WATER PERMIT NO. 5145-3

Applicant Paul M. Juel

DAM INSPECTION HYDROLOGIC ANALYSIS - COMPUTED PROBABLE MAXIMUM FLOOD HYDROGRAPH (LAKE INFLOW HYDROGRAPH)
JUEL DAM

JUEL DAM
SW 1/4 SEC 31
T99N-R48W
LINCOLN CO. SD.

PAUL JUEL DAM SPILLWAY RATING CURVE

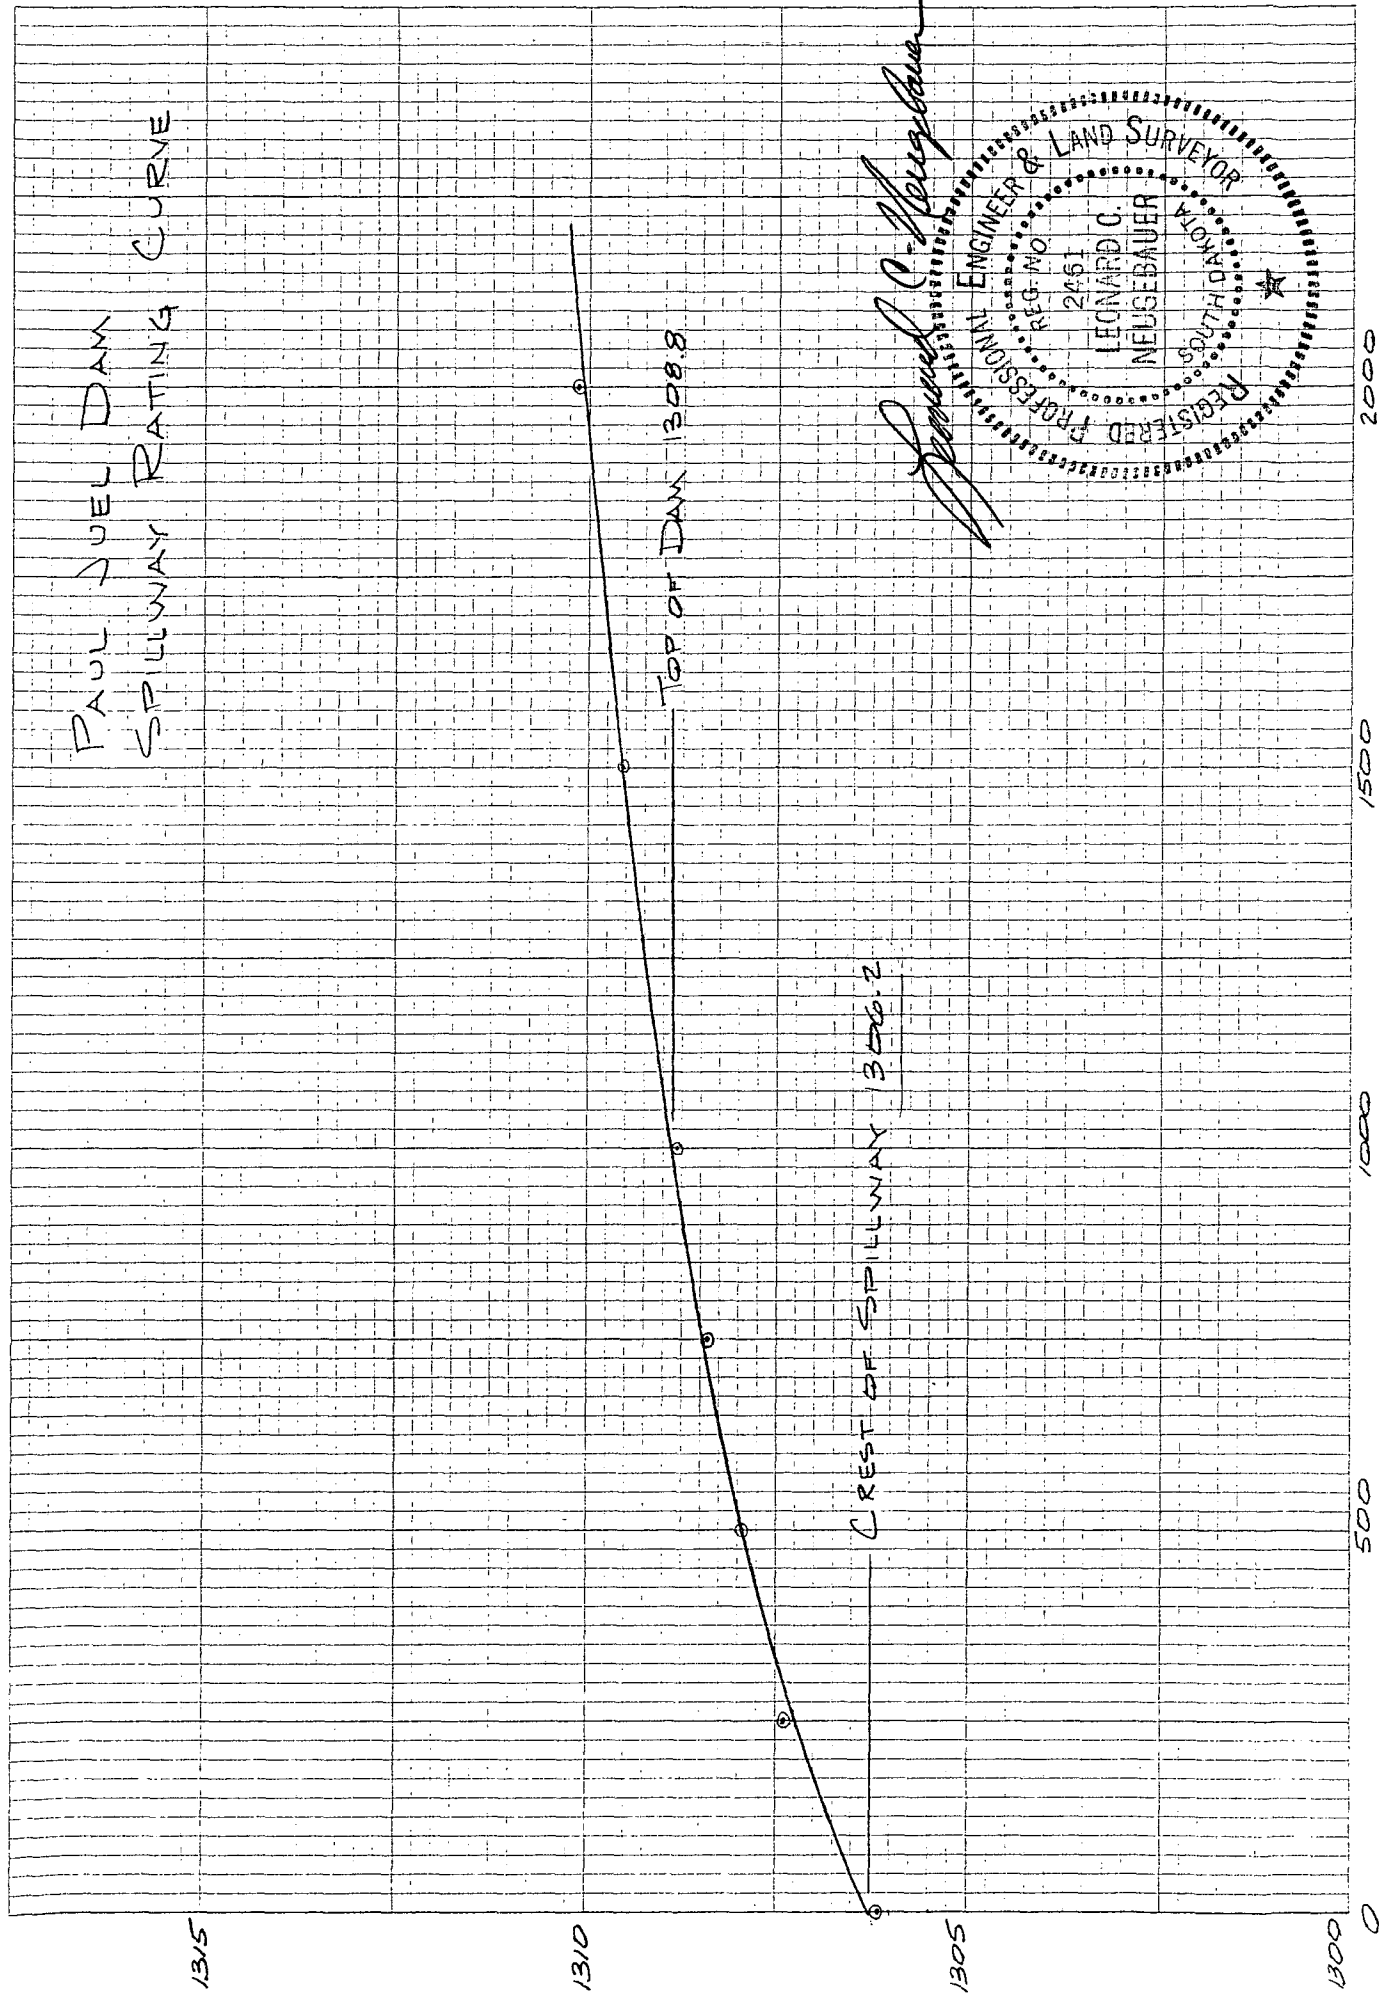
The Water Rights Division received the spillway rating curve, a cross-section diagram and spillway flow calculations for the dam on August 30, 1988. Additional information is needed to complete the plans and specifications as outlined in Chapter 74:02:08. The portions of the plans and specifications received on August 30, 1988 are not complete without the signature of a SDRPE or by someone under the supervision of a SDRPE as described above.

At the October 5 and 6, 1988 Water Management Board meeting the Board recognized Mr. Juel's difficulties in obtaining a complete set of plans and specifications. The Board made a motion to accept your field survey and rating curves as a final as built inspection if we could obtain your signature and professional registration seal on them. The Board would then consider the above qualification satisfied with your final inspection along with the preliminary design information we have received.

PAUL DUKE DAM
SPILLWAY RATING CURVE

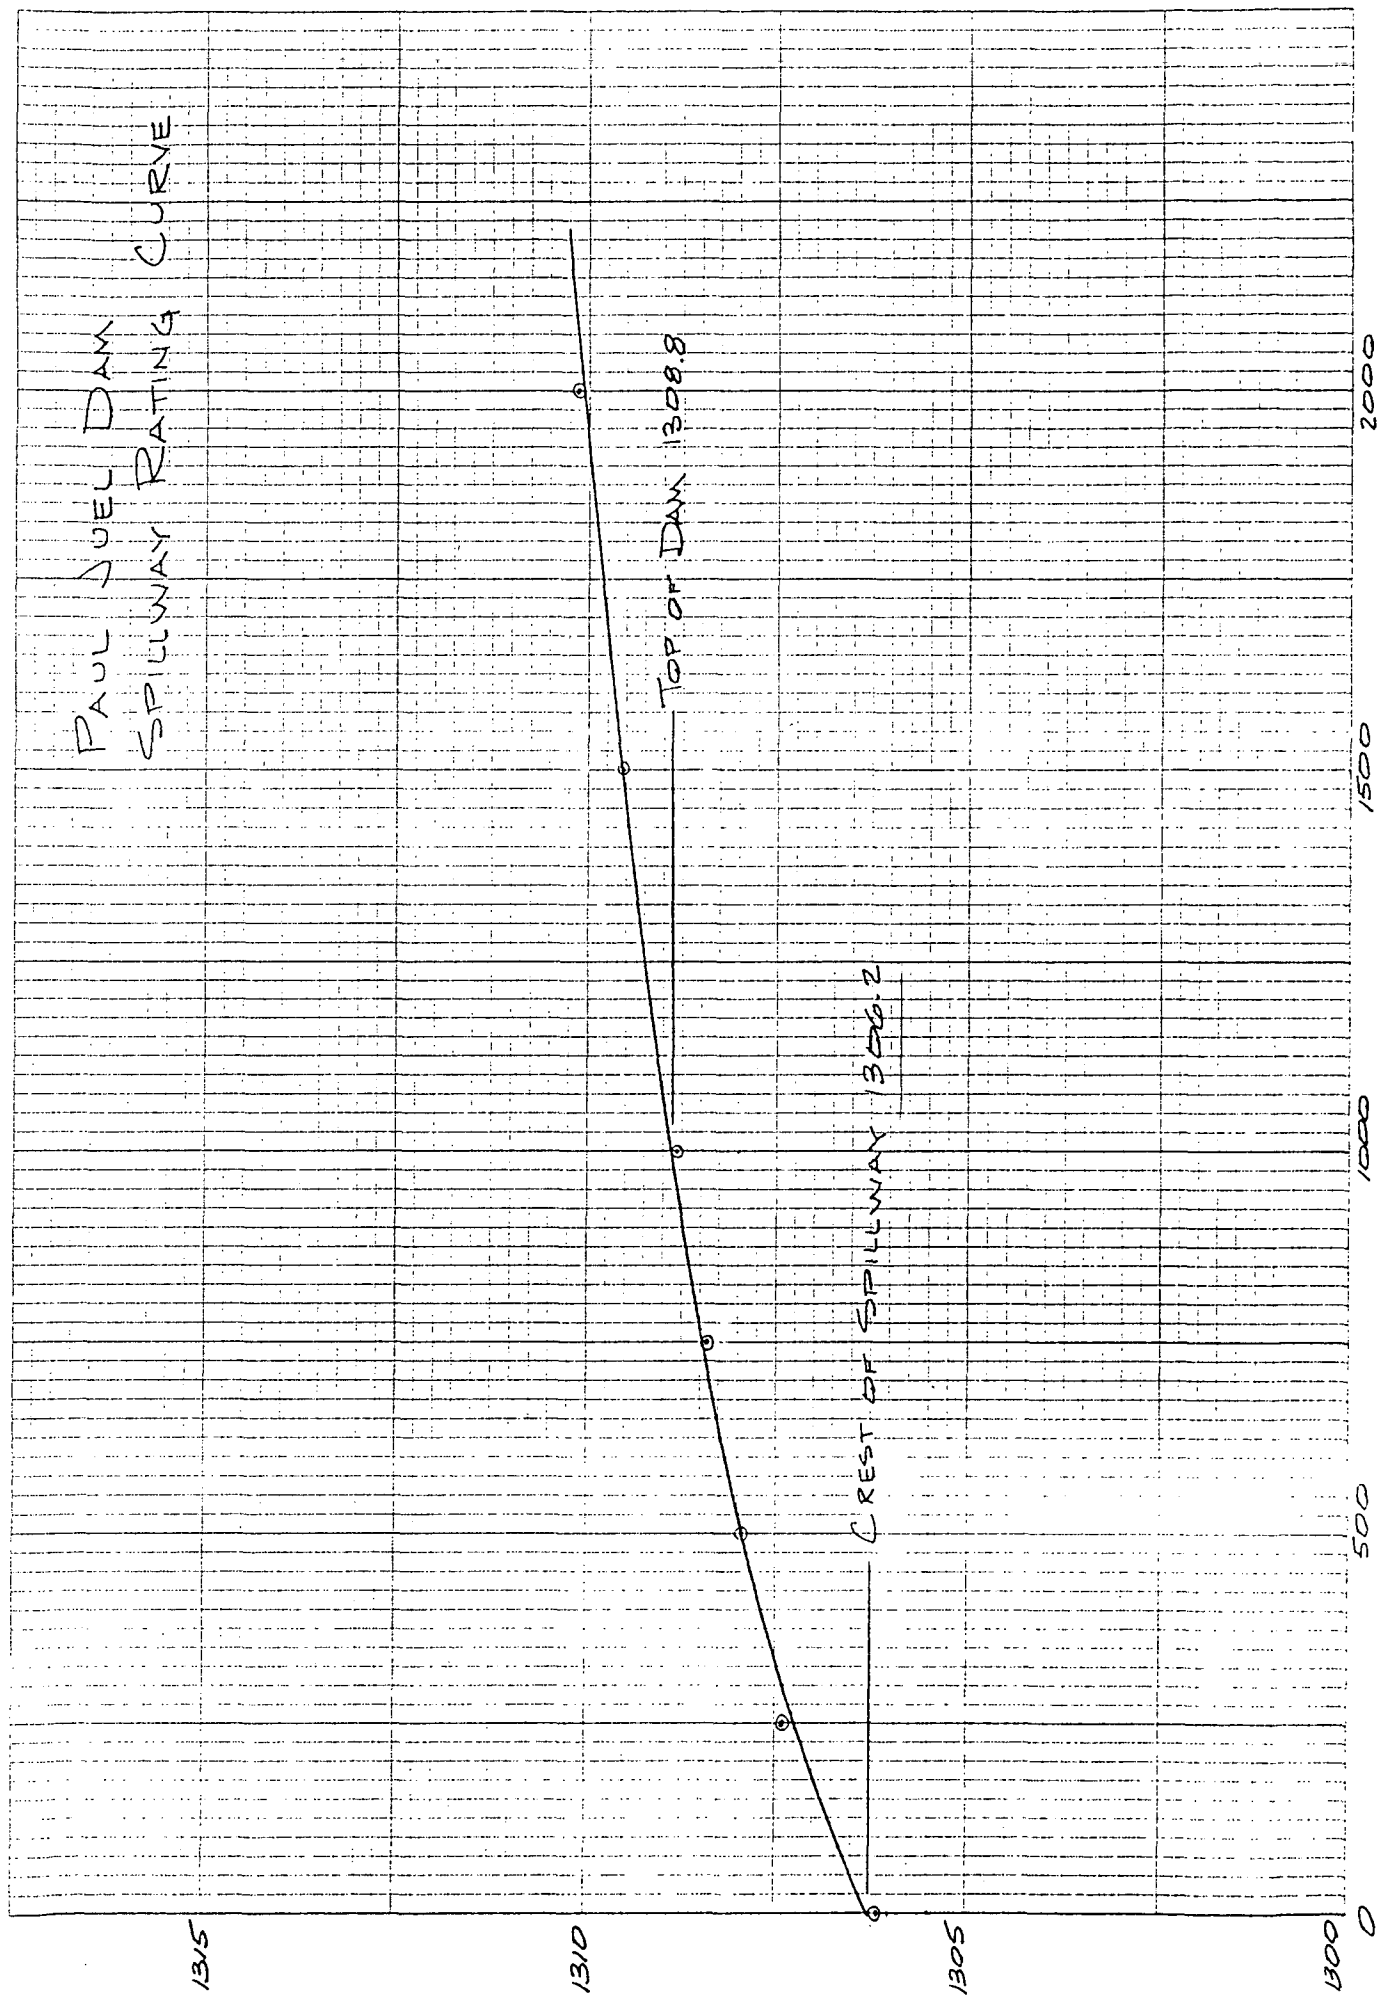
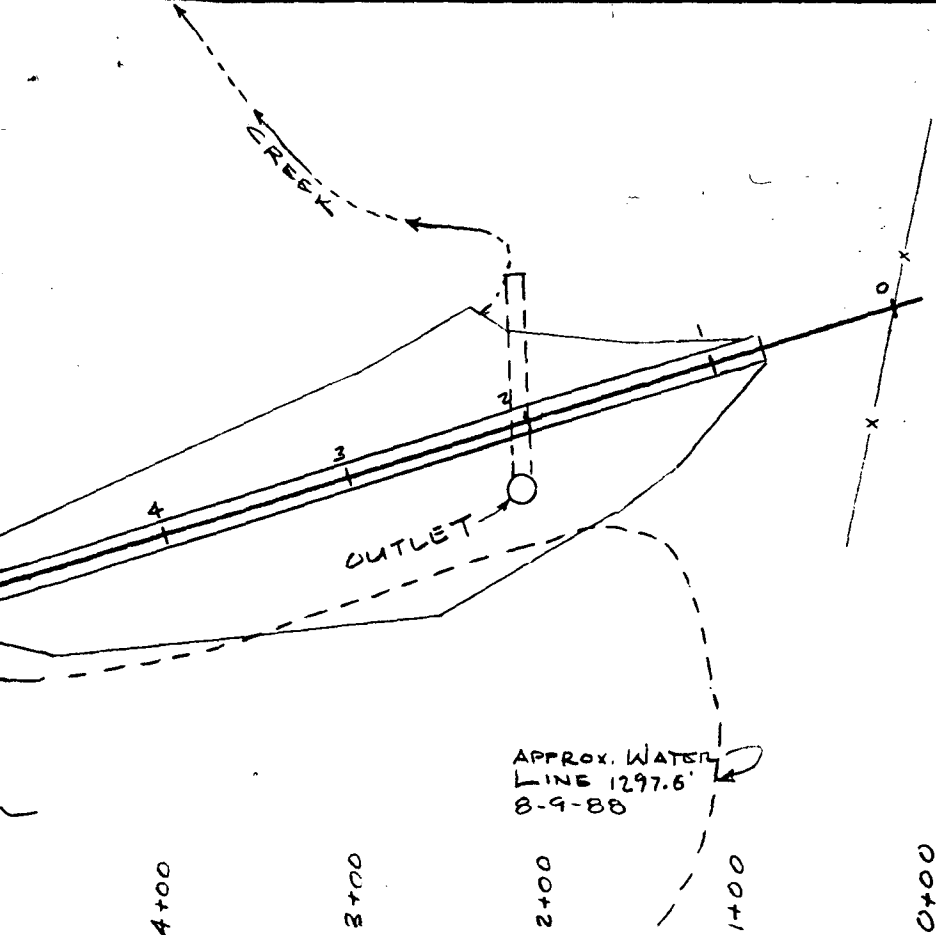
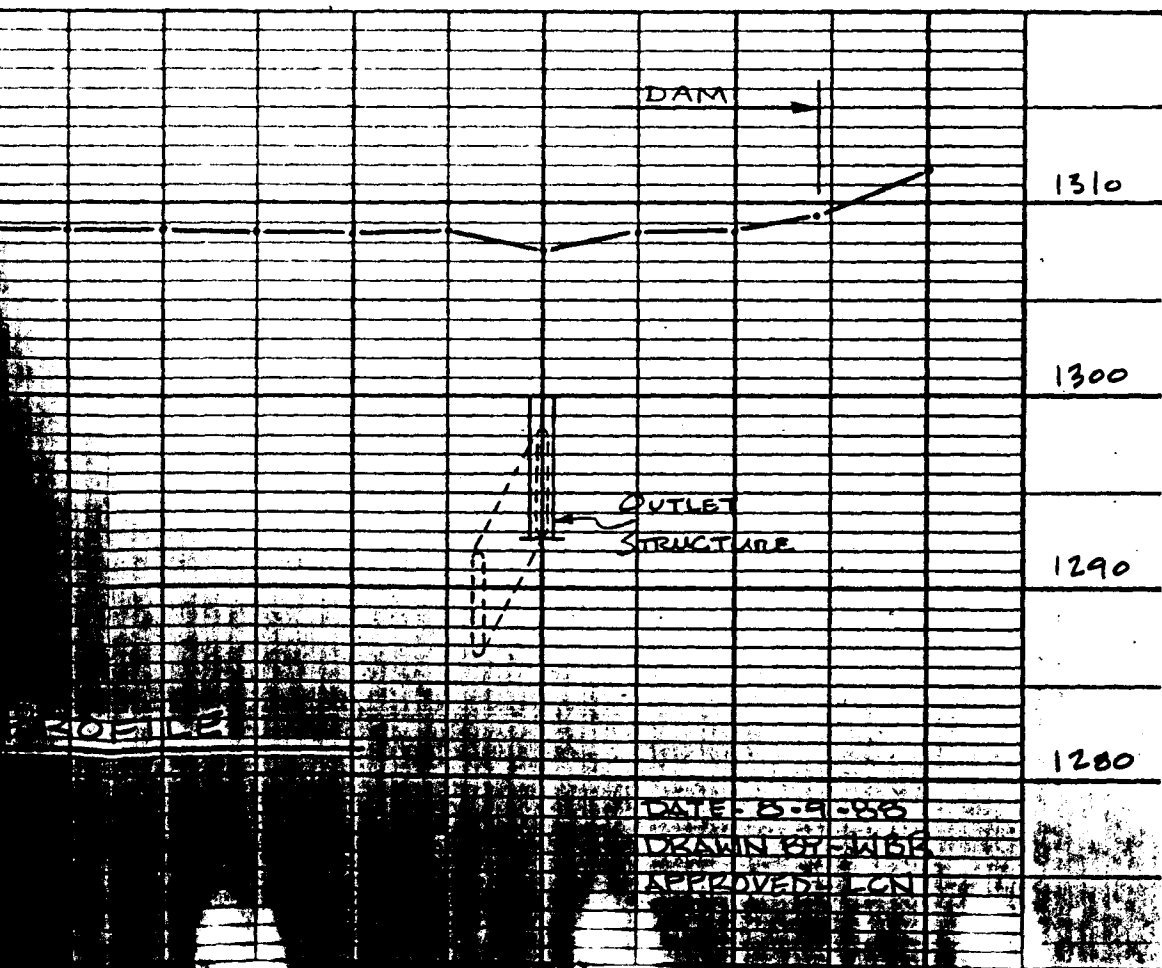
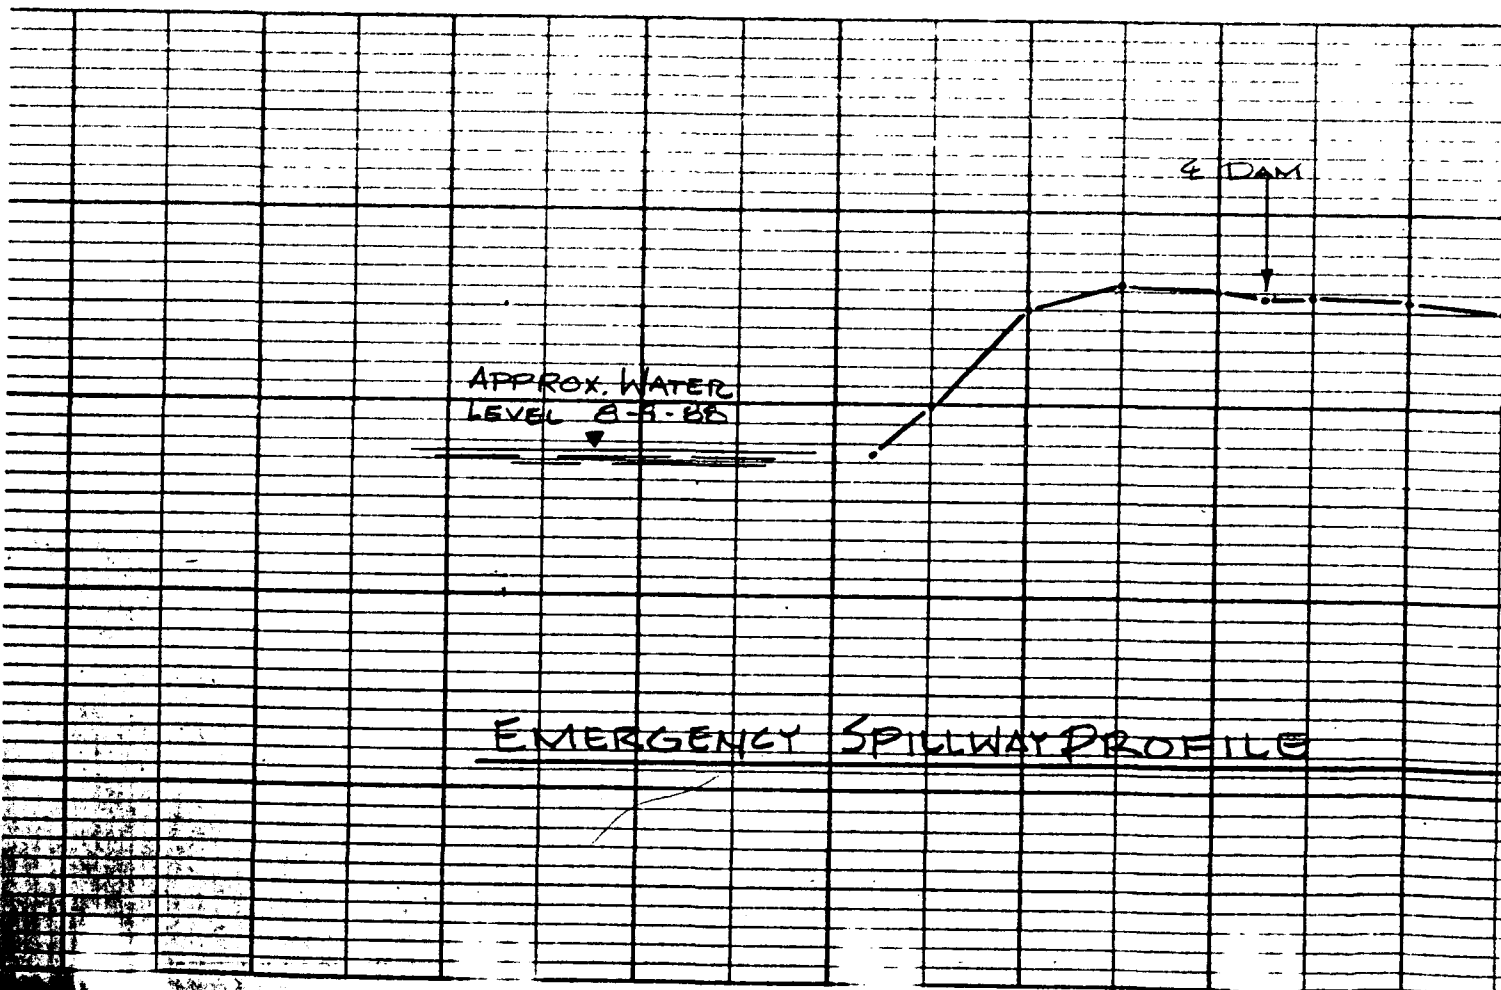
As indicated by the drawings, our field survey has revealed that the dam was constructed within reasonable tolerances of the planned dimensions and elevations shown on the copy of the construction drawings which you provided us. We understand that you are interested in the possibility of raising the elevation of the crest of the spill tube, in order to increase the normal elevation of the lake surface. We can understand your interest since at the present time the lake is about 2.3' below the crest of the spill tube as a result of the drought conditions that have occurred this spring and summer. It appears to us that it is indeed possible to accomplish this by simply welding some additional pipe onto the existing 96" CMP spill tube so that the lake surface must reach a higher elevation before it overflows and drains into the creek below. We suggest that you request permission for such raising from the SD Department of Natural Resources in Pierre. With the information that we have developed during

Before raising the crest of the spill tube, we suggest that you should also consider the impact of such raising of the lake level on the evergreen trees which you have planted on the high area upstream of the north end of the dam. These trees may die if inundated for a significant period of time by a higher lake surface.
